City Council Special Meeting Agenda

Approve Change Order #1 for the Beacon Hill Water Tank and Water Main Extension Project

Change Order

Project: BEACON HILL WATER TANK & WATER MAIN EXTENTION PROJECT	Owner: City of Cody, Wyoming	Owner's Contract No.: 2020-01
Contract: Beacon Hill Water Tank & Water Main Extension Project		Date of Contract: May 4, 2020
Contractor: Harris Trucking & Construction, Inc.		Engineer's Project No.: 171133

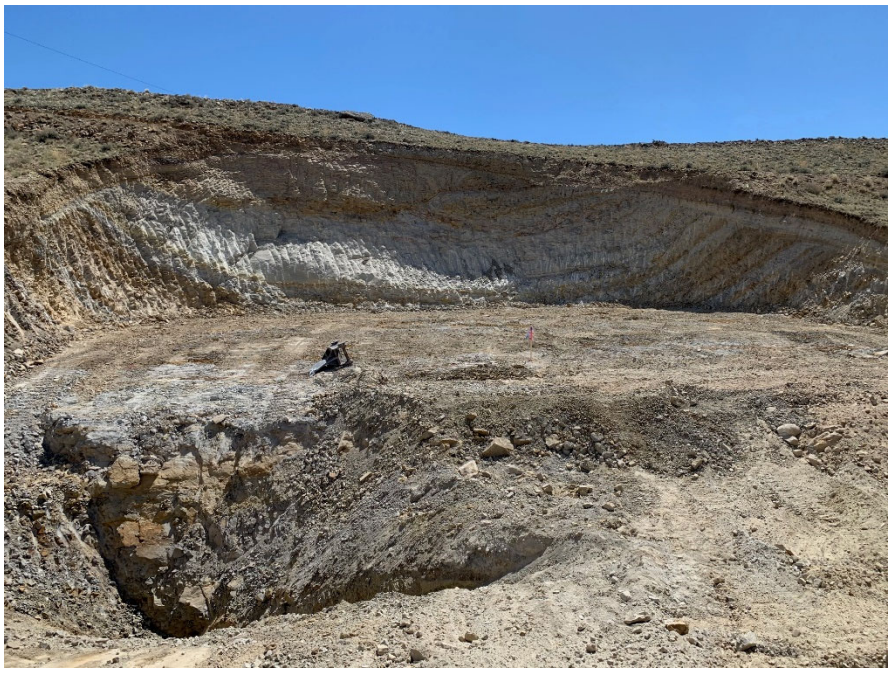
As requested, on Thursday, June 11, 2020, I traveled to the site to perform an excavation observation for the referenced project. It was brought to our attention that competent bedrock was not encountered along the west edge of the proposed tank footprint. Upon arrival, excavations for the tank were at or near planned subgrade elevations. Competent bedrock was present throughout most of the tank footprint. However, along the west edge of the planned tank footprint, the bedrock appears to dip steeply. A test pit was excavated in an attempt to find competent rock and it was not encountered within the ±20 feet of excavation depth. The picture below shows the excavation looking east.

1) Continue to excavate down until competent bedrock is encountered and bring back to grade with structural fill while still benching into the bedrock per the geotechnical report.
2) Install some sort of pier foundation system to support the west tank wall.
3) Move the tank to the east further into the hillside to ensure the tank is fully supported on the competent rock.

In our opinion and based on our conversations on site, option 3 seems to be best option. This will provide for subgrade uniformity and stability for the tank. Also, with this option, benching of the excavation can be omitted since competent rock will be encountered at a uniform depth.

WATER TANK PLAN AND PROFILE SHEET 2
BEACON HILL WATER TANK & WATER MAIN EXTENSION PROJECT

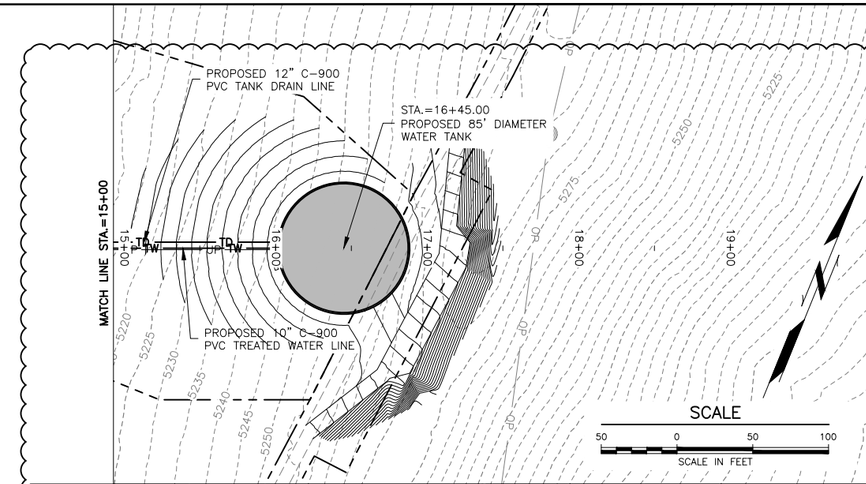
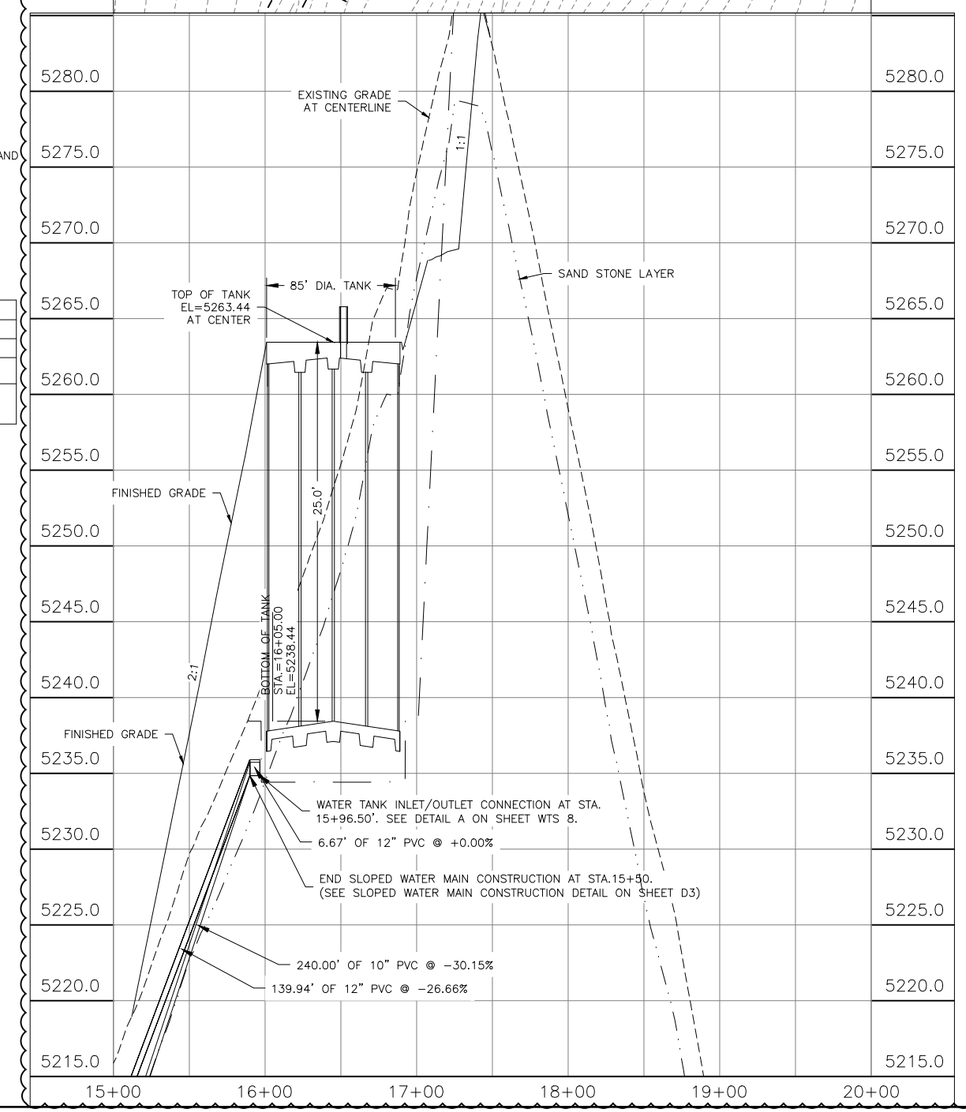
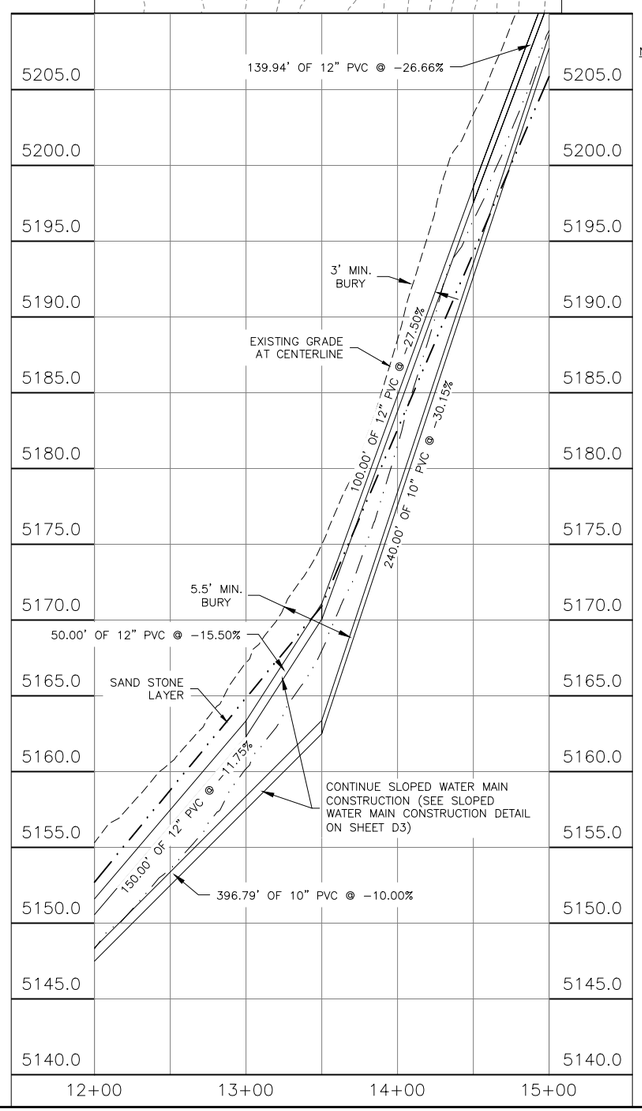
Δ C.O.#1

NO.	DESCRIPTION	DATE	BY
1	CHANGE ORDER #1	6/18/2020	TJI

BEACON ACCESS ROAD PLAN AND PROFILE SHEET 3
BEACON HILL WATER TANK & WATER MAIN EXTENSION PROJECT

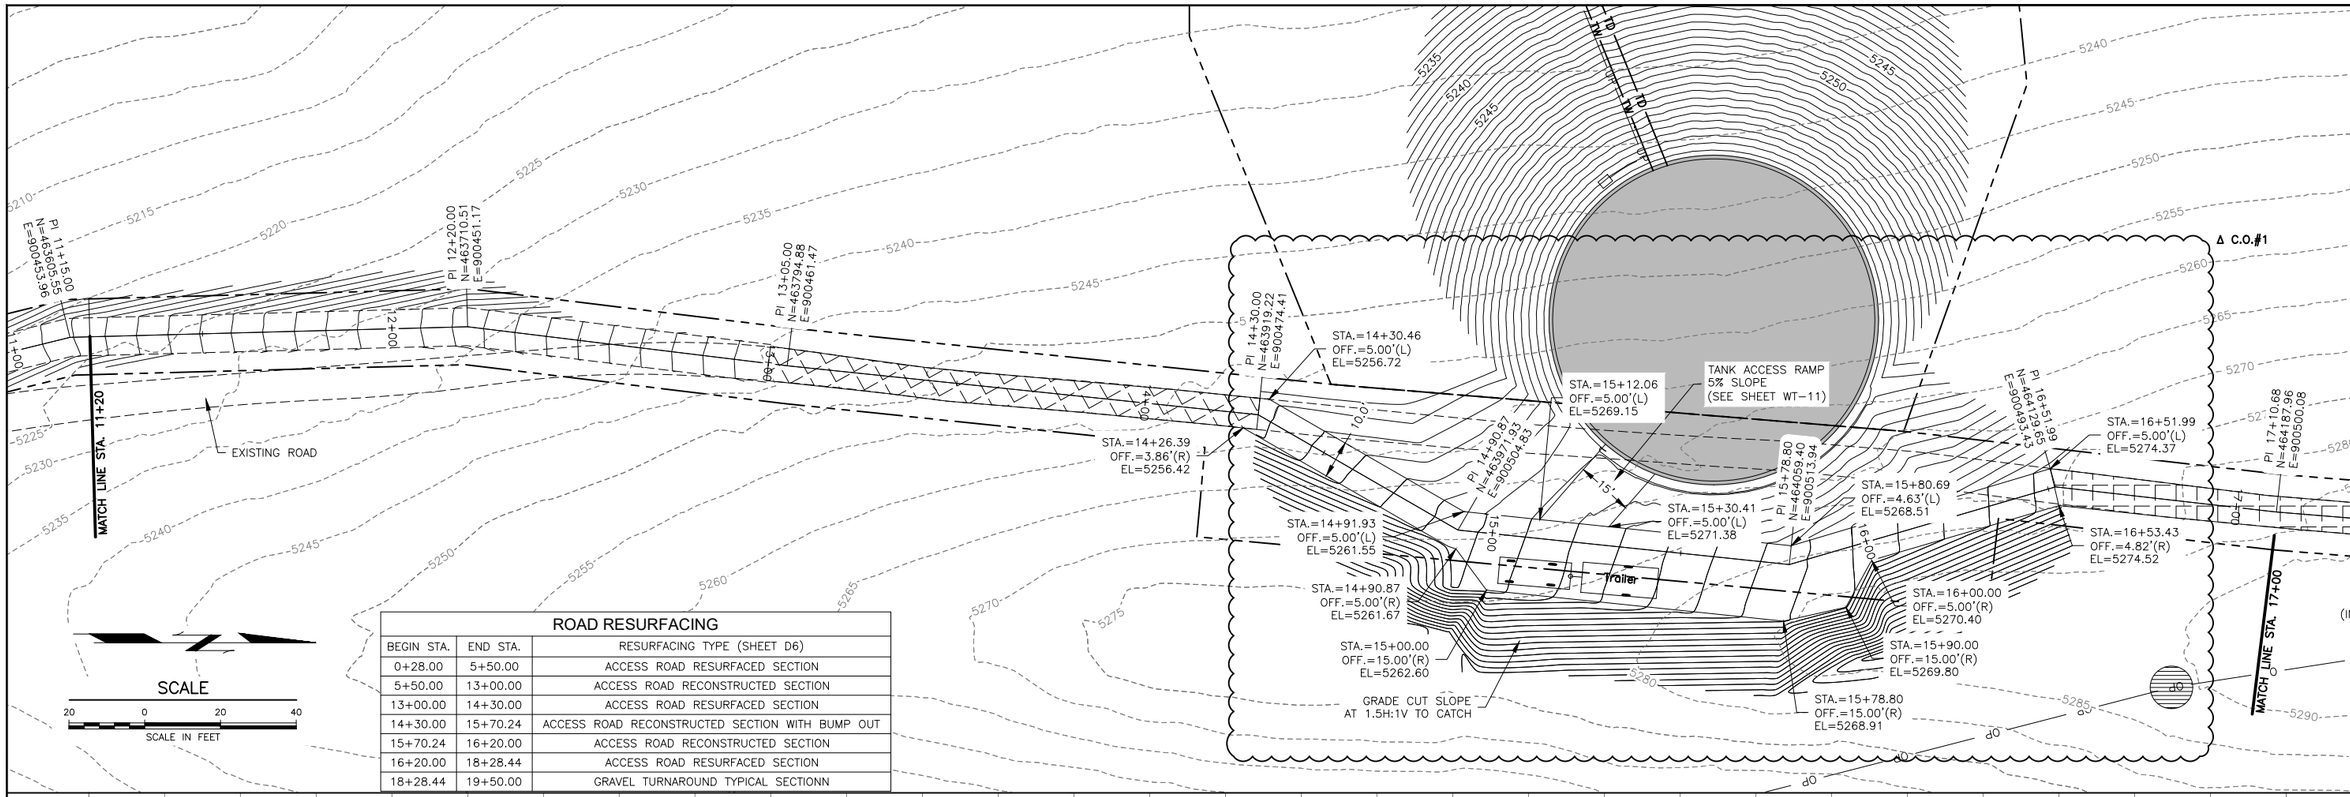
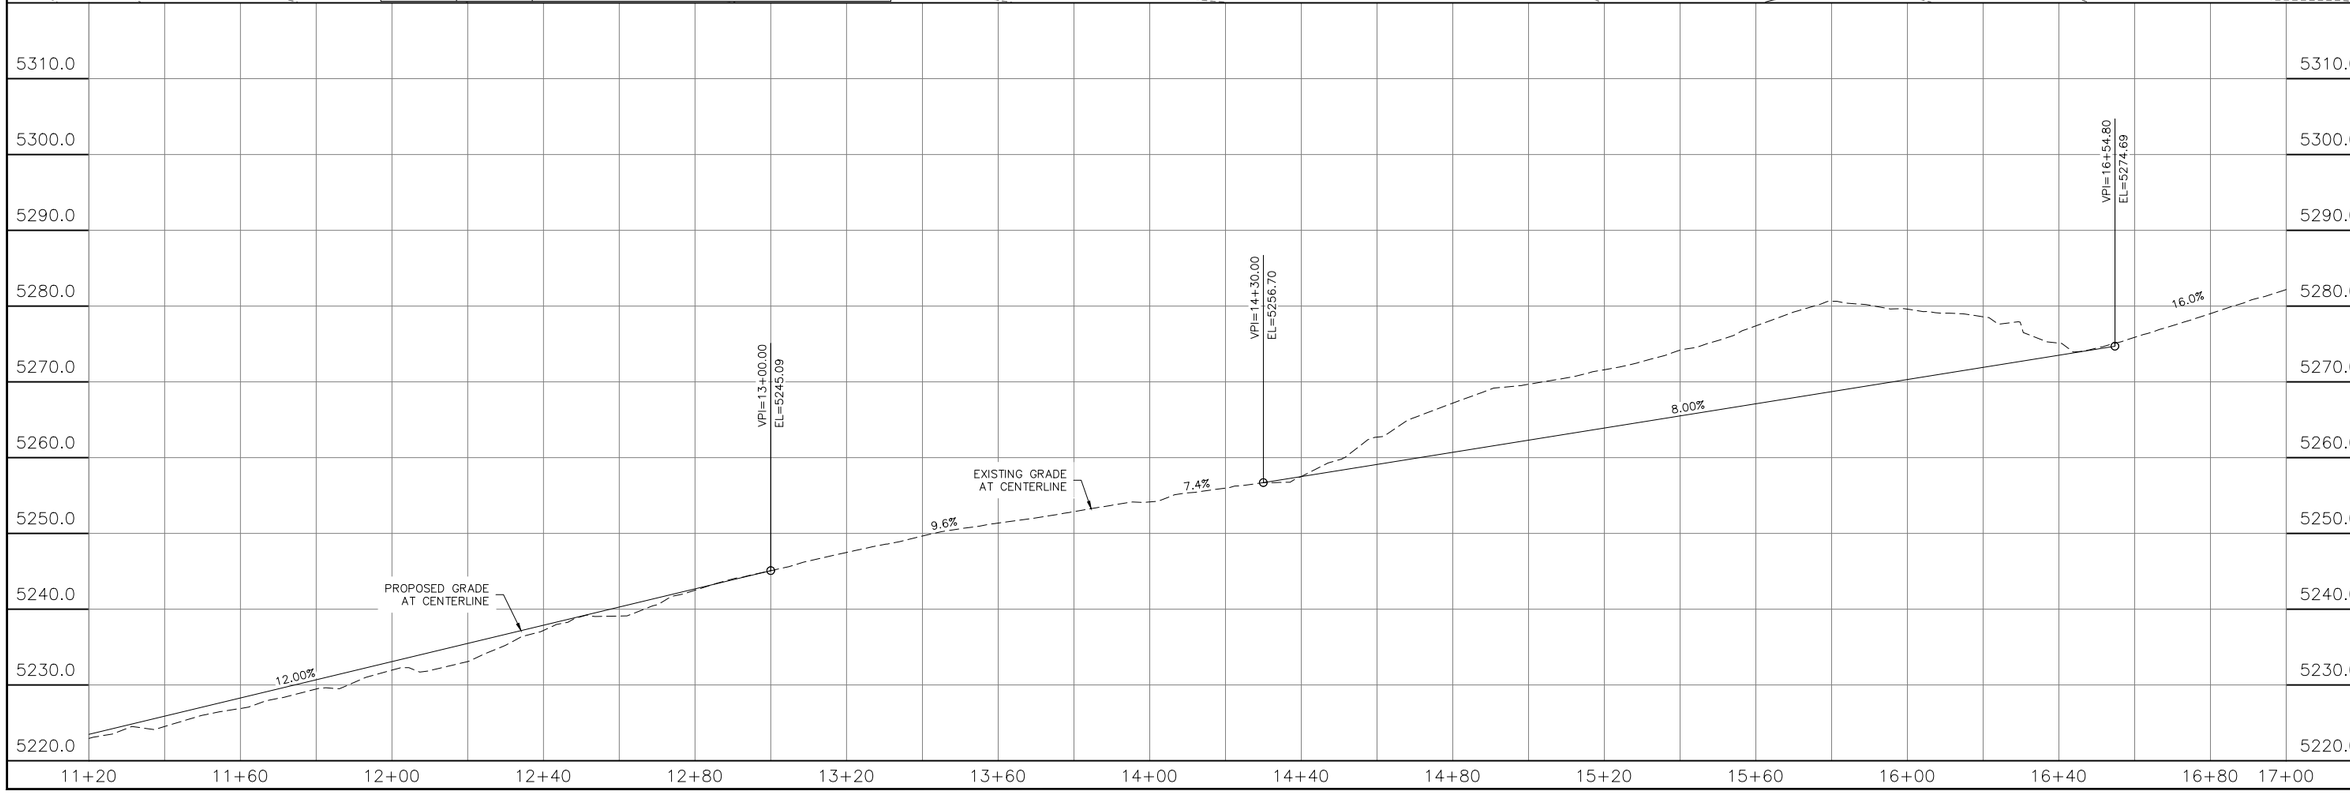
NO.	DESCRIPTION	DATE	BY
1	CHANGE ORDER #1	6/18/2020	TJI

WATER TANK ACCESS
BEACON HILL WATER TANK & WATER MAIN EXTENSION PROJECT

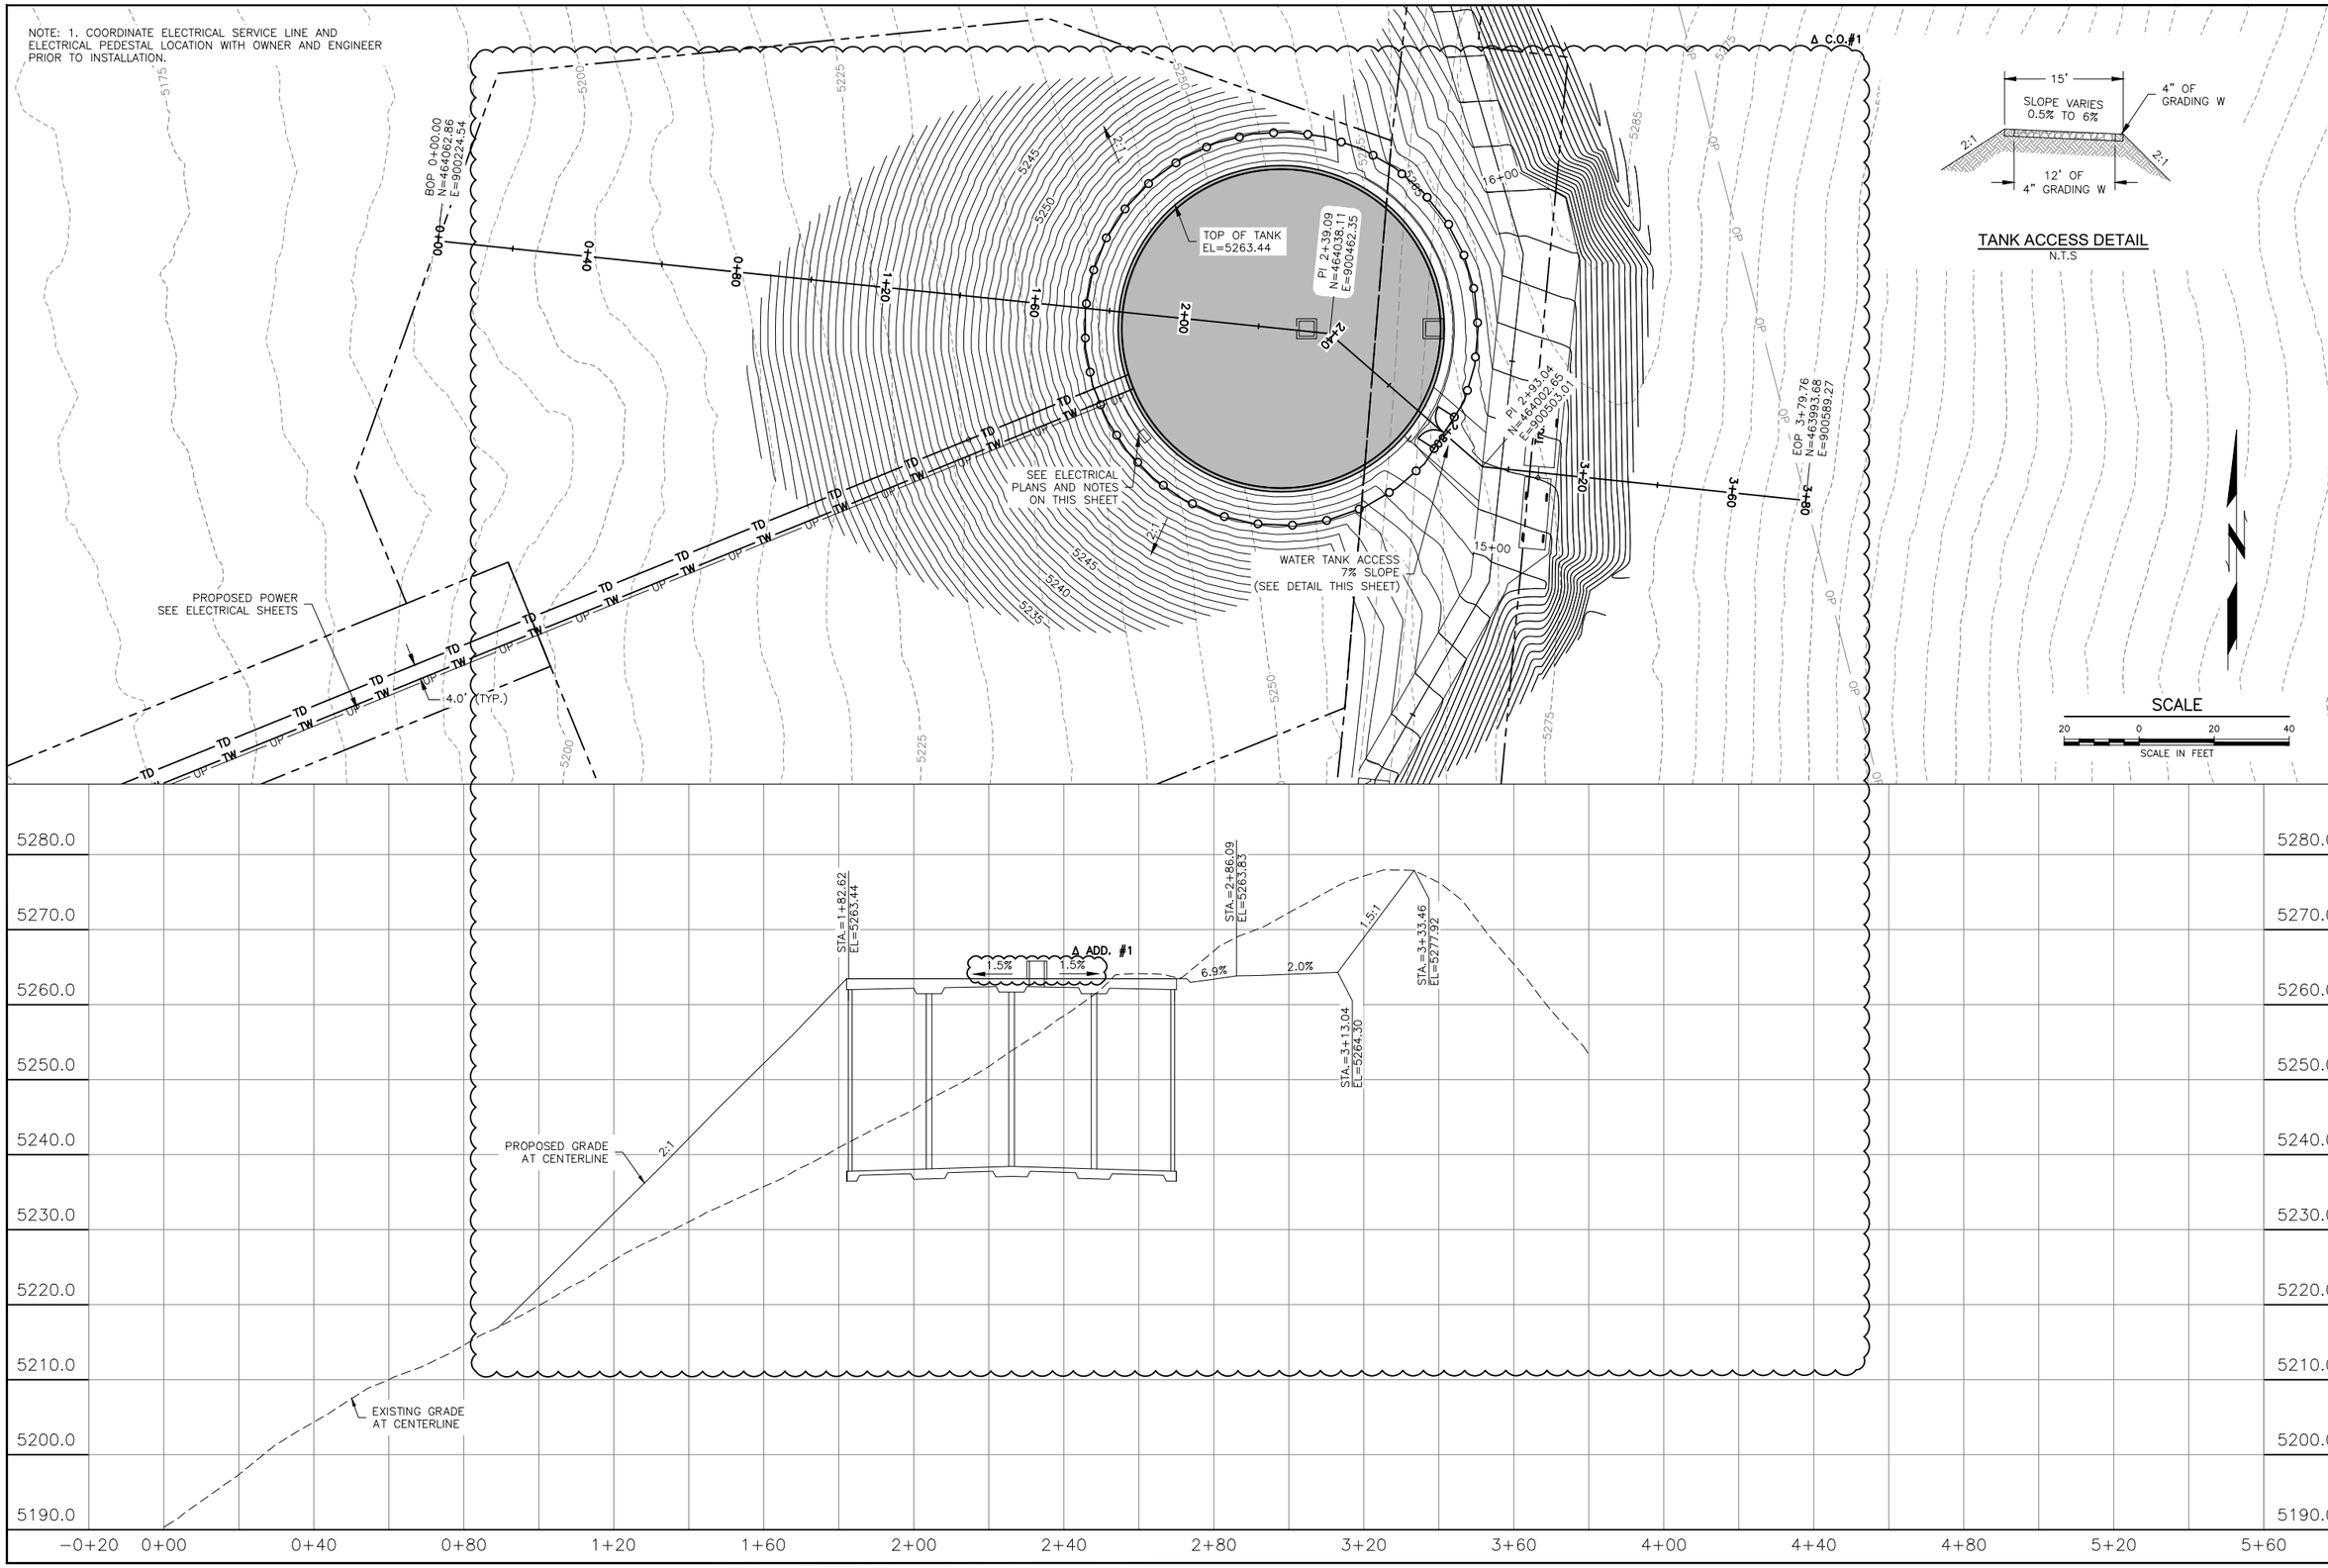
NO.	DESCRIPTION	DATE	BY
2	CHANGE ORDER #1	6/18/2020	TJI
1	ADDENDUM #1	05/11/20	ABK
